Detailed Site Plan Skyline Subdivision

DSP-19059

SUBJECT: Detailed Site Plan DSP-19059
Type 2 Tree Conservation TCP2-016-2021
Skyline Subdivision

Figure 1: Site Plan

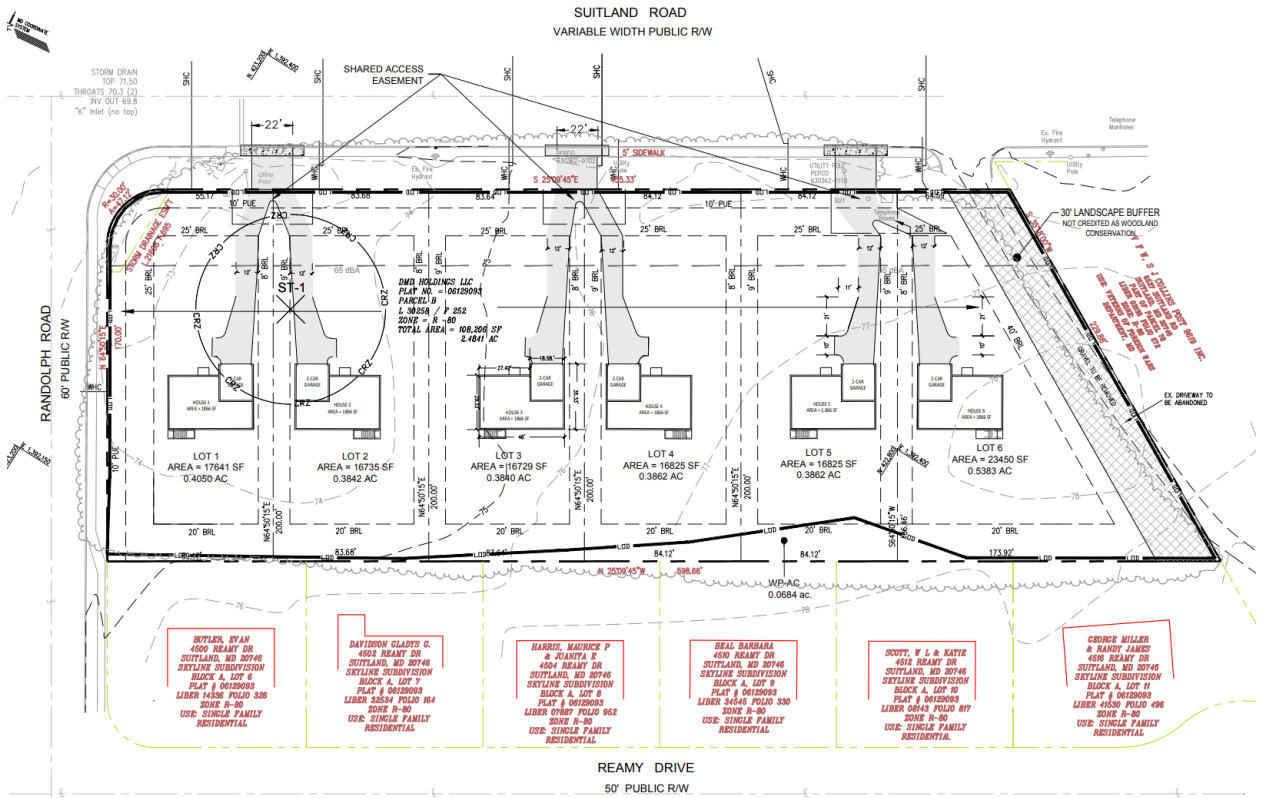
- 6. Design Features:** The subject 2.48-acre parcel is a trapezoidal shape fronting on Suitland Road. The subject DSP is proposing six single-family detached residential units served by three shared driveways, with shared access easements, from Suitland Road. Each lot contains a 1,866-square-foot house with a two-car, front-loaded garage, and a 12-foot-wide driveway with a turnaround. The Sebring model, by Arundel Station Homes, will be used for each of the houses, with four different front elevations that offer a variety of features and rooflines. The elevation options include asphalt shingles, stone, brick and/or siding, shutters, enhanced window trim, side lights, and a covered front porch. Each elevation includes quality building material that staff considers acceptable. However, the side

elevations need more features, as has been conditioned herein. No signage or lighting is proposed or required.

- e. Provide a minimum of two standard features on each side elevation, with three features to be provided on the side elevation facing Randolph Road.

SITE PLAN

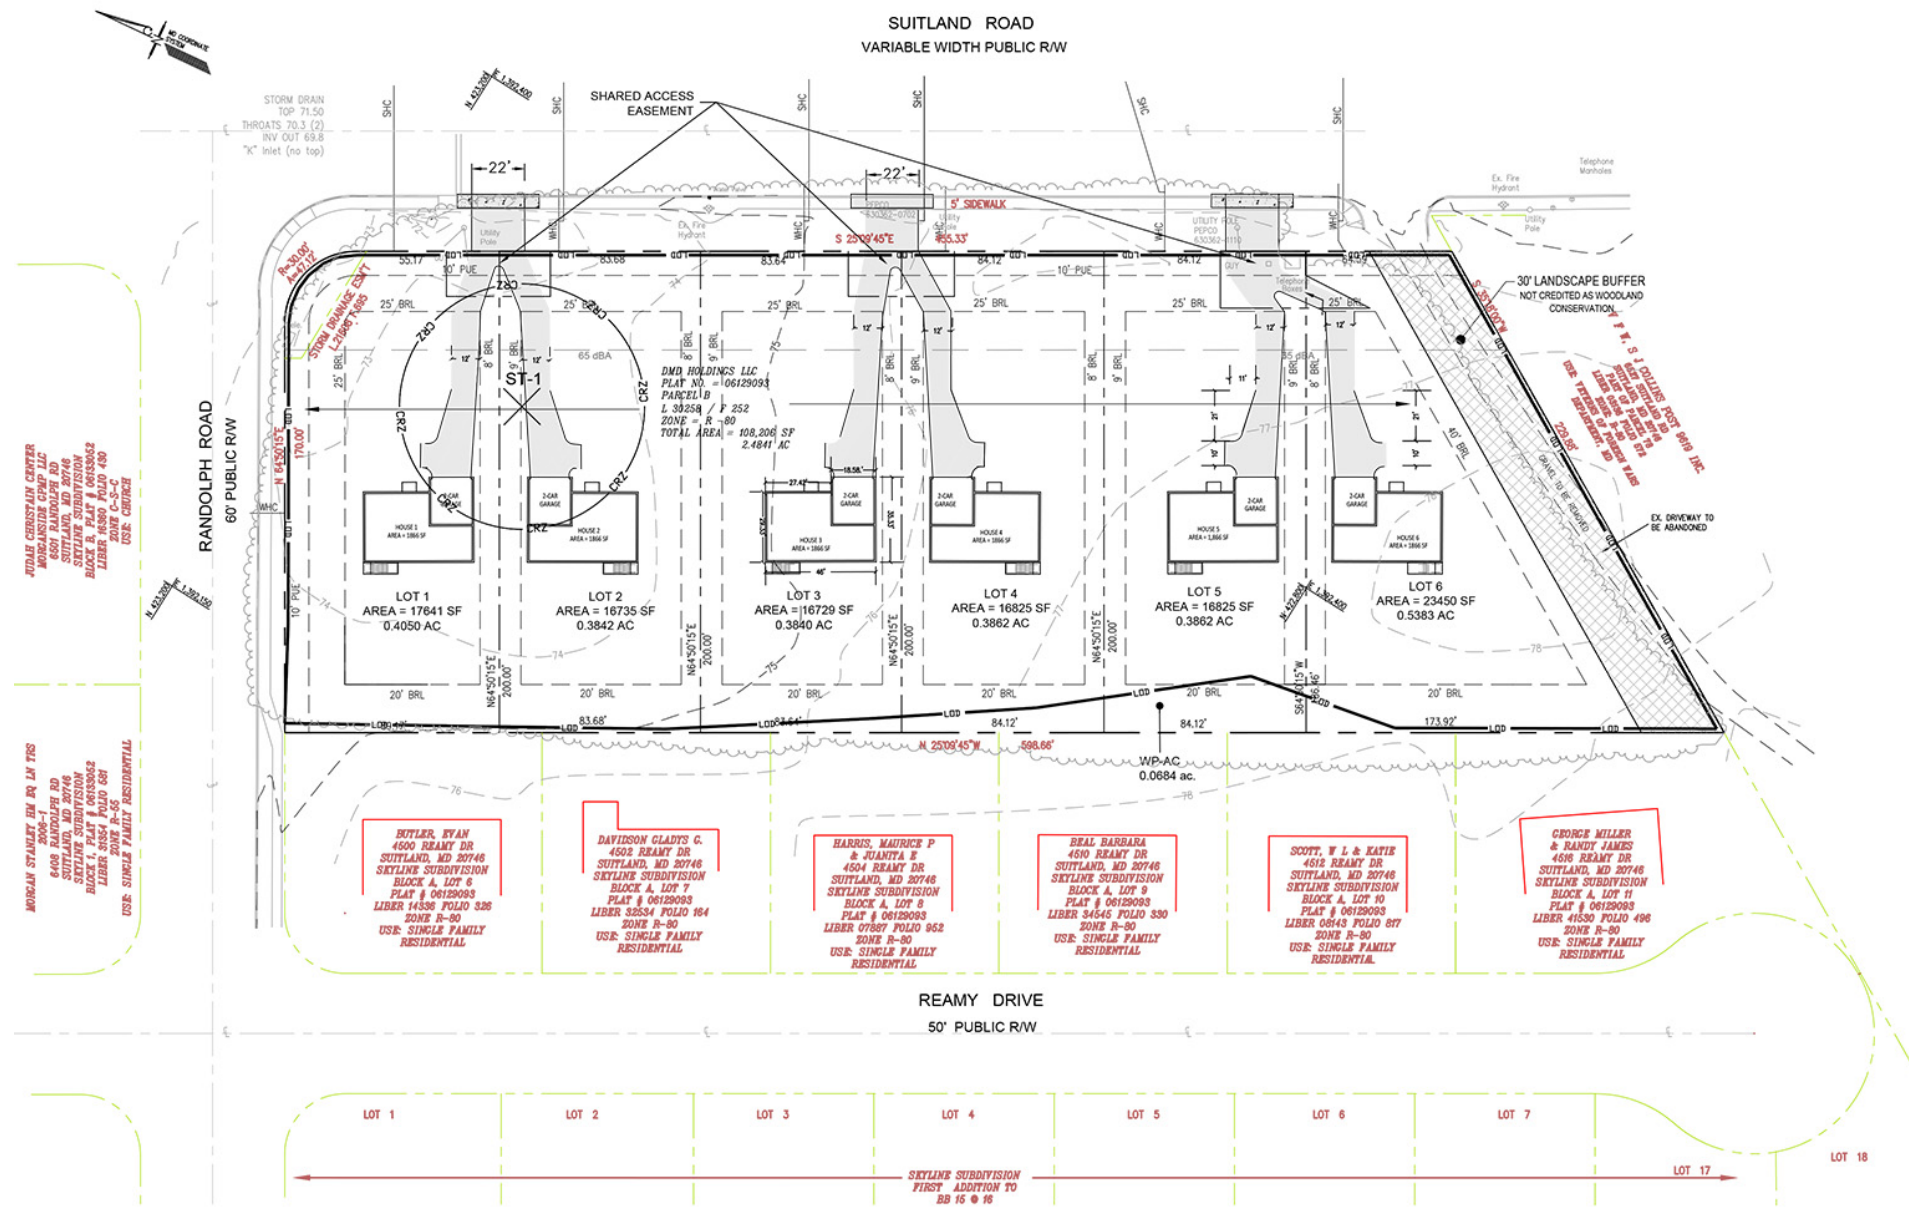
The DSP does not clearly indicate a 10-foot-wide landscape strip along the front of Lots 1 through 6 with appropriate plant units and materials, outside the 10-foot-wide public utility easement. A condition is included herein requiring this to be provided and labeled on the plans.

The DSP reflects three shared access points to Suitland Road. However, the plans should also reflect denial of access to Suitland Road and Randolph Road, except for the three allowed access points, as conditioned herein.

- b. Provide a 10-foot-wide landscape strip along the front of Lots 1 through 6 with appropriate plant units and materials, outside the 10-foot-wide public utility easement.

- c. Show and label denial of access to Suitland Road and Randolph Road, except for the three shared driveway access points to Suitland Road.
 - d. Provide the dimensions of the front porch/stoop, indicate if it is covered, and provide the dimensions of the optional extension and optional chimney.

- f. Provide the actual setbacks from the house to each property line on the site plan for all lots.
 - g. Demonstrate the lot coverage and height of the houses on the site plan.

- h. Show the proposed grading and stormwater management features on the DSP.
 - i. Provide the amount of the fee-in-lieu of the mandatory dedication of parkland in the General Notes of the DSP.
